UDC 2013 Annual Review:

High Priority—Quick Fixes

June 19, 2013

Revision # 1 Figure 4-18 adjustment (Section 6 of Ordinance)

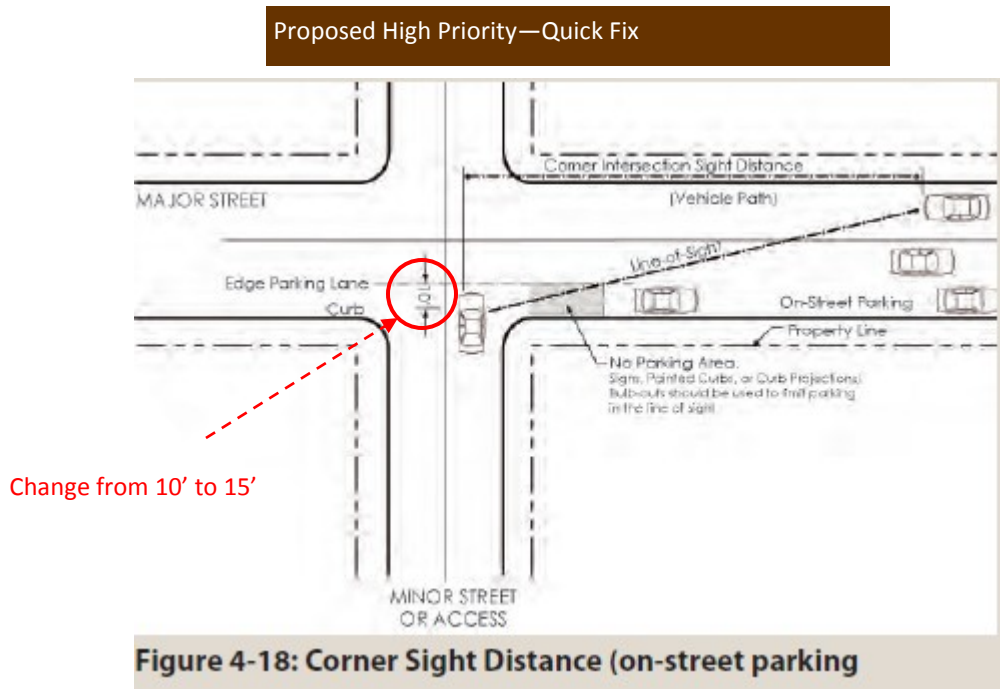
(ref. 4.3.5c, Figure 4-18: Corner Site Distance (on-street parking), page 4-29) Adjust a calculation number to increase site triangle visibility, but reducing on street parking. (UDC Annual Review Item g1)

Change the 10' to 15'.

Revision # 4 Residential Rear Setbacks correction (Section 9 of Ordinance)

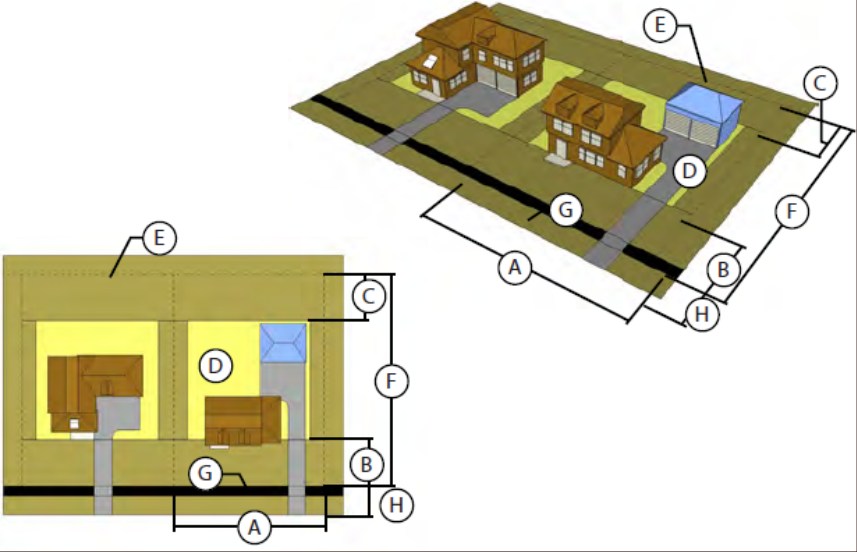
Change the Rear Setback for the Principal Building from 25’ to 20’ for Lot Types: DD5, DD6, DD7, DD8, SD1, SD2 & SD3. This was a typographically error

6.7.2 Applicability

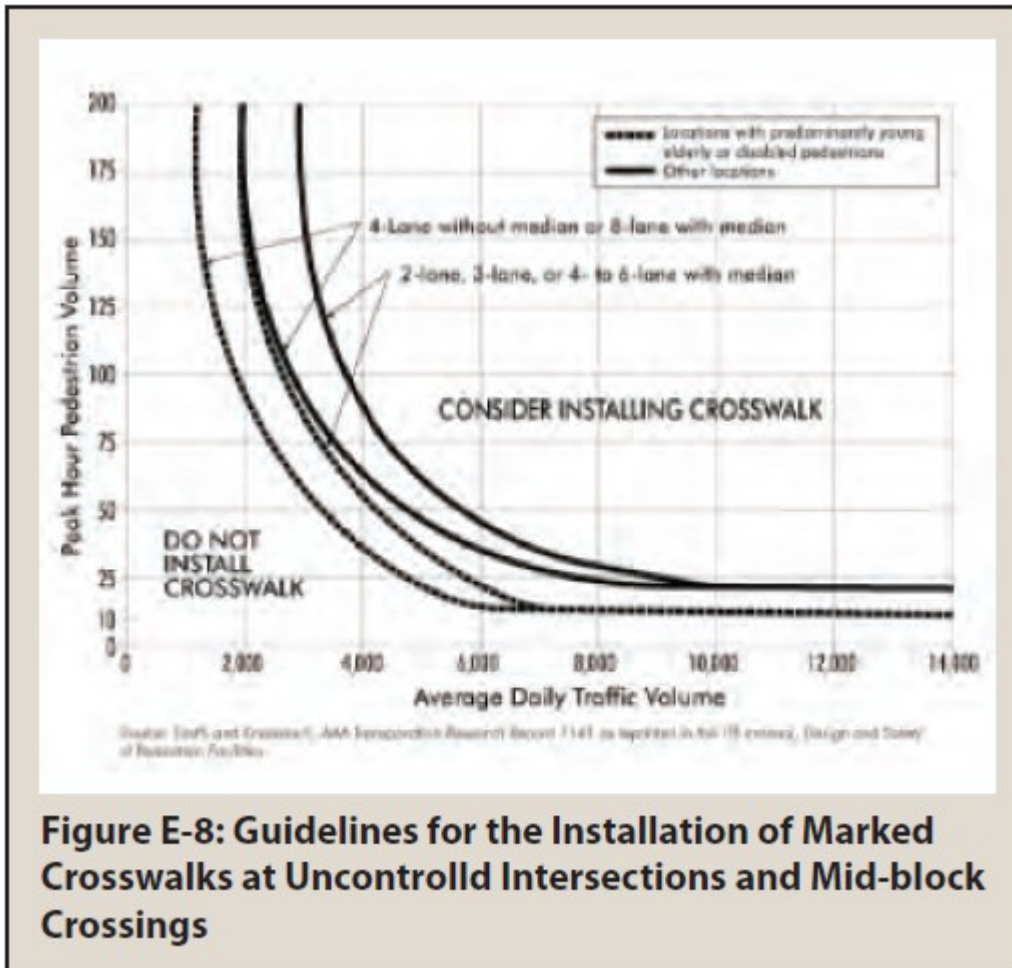
- a. NB
- b. MUR
- c.MUB
- d. CBD
- e. PUD, but subject to modification through the planning and review process.
